**Post-examination Comments**

**FARLEY JAN. 2005 EXAM  
50-348 & 50-364/2005301**

**JANUARY 10 - 14, 2005  
JANUARY 18, 2005 (written)**

1. Licensee Submitted Post-examination Comments

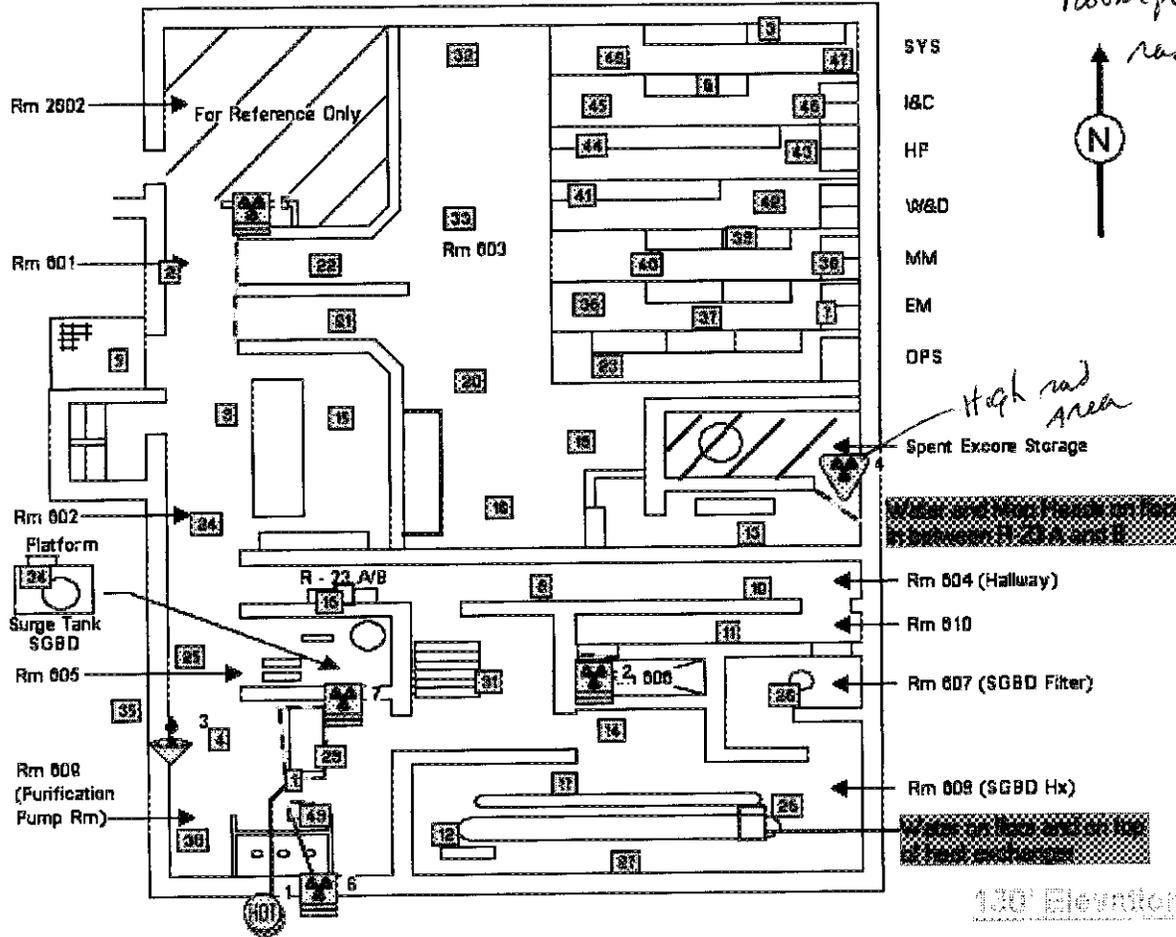
Upon review, one individual picked "A" as the correct response. We contend that both responses "A" and "B" are correct depending on factors that are not provided in the stem of the question. A review of plant and NRC Health Physics policies and Reg. Guides revealed the following:

- From the "Floor Walk down" checklist posted on the health physics home page - Minimize the size of each area posted to just the area affected. (e.g. If just 1 corner of a room is a High Radiation Area, only post that portion of the room as a HRA and not the entire room) This would justify "A" as the correct response for a larger room. Since the High Radiation Area (HRA) posting would only be required at a distance of 1.5 ft. from the source (boundary of 100 mrem/hr field, it would not necessarily require posting the entrance to the room as a HRA. In this question the entrance is four feet away.

Practical experience as a System Operator where high radiation areas in larger rooms are posted closer to actual boundaries based on the radiation fields rather than the door to the room led one particular candidate to choose response "A" after ascertaining the dose at the entrance 4' away was <100 mrem an hour. This is consistent with the posting practices of the FNP Health Physics department. The facts are that the high rad area would be posted at approx. 1.5 feet from the source, and at the entrance the reading would be 12.5 mr/hr. This would not constitute a high rad area posting for the entire room.

**Enclosed in the comments are two maps performed at FNP on 01/07/2005 and one from 01/18/2005 that shows this is how we do business at FNP.**

We submit based on these facts that both answers "A" and "B" are correct.
